Bodybuilder's Bulletin

Bulletin No. 112

Subframe Requirements for Tipper Installation

FLITCH DETAIL
MAT'L: QStE420TM

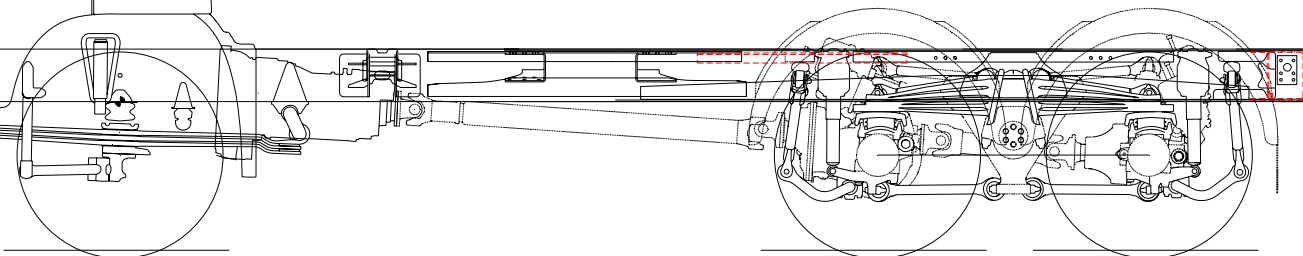
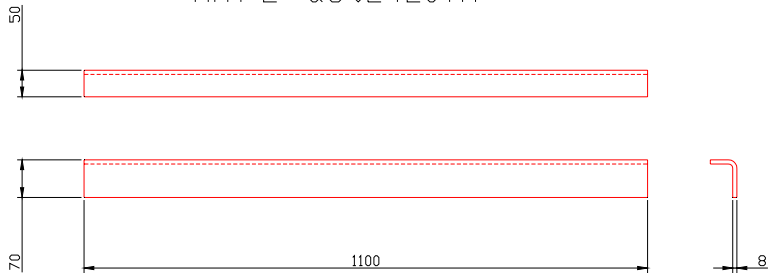
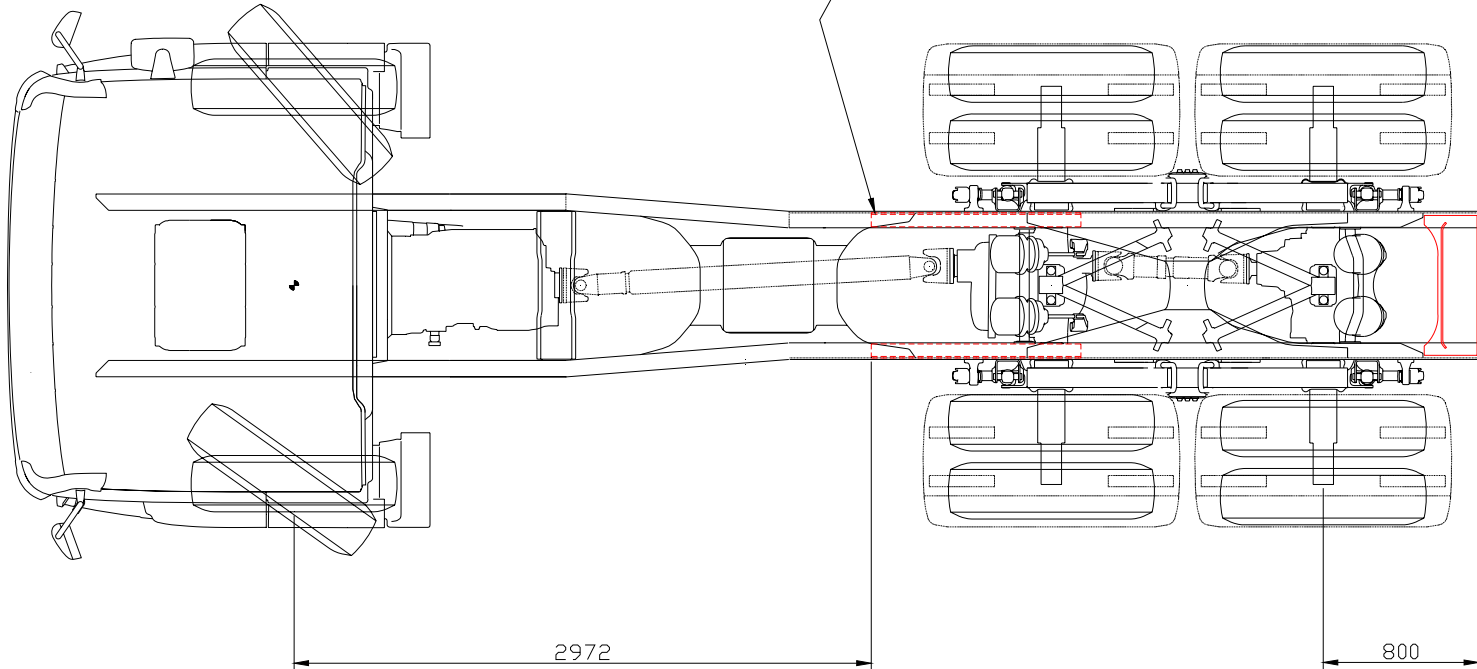
In addition to the three chassis types listed above, the TGS 6x4 Rigid (chassis type L26S) can be fitted with a tipper body without a subframe providing the following modifications to the chassis are made:

- Installation of 8x4 type rear cross member (Part No 81.41250.5187)
- Installation of chassis flitching (see drawing on following page)

REPLACE EXISITING CROSS MEMBER WITH 81.41250.5187

2 No. FOLDED FLITCHES BOLTED INSIDE
CHASSIS RAILS AS SHOWN (PACKERS REQUIRED)
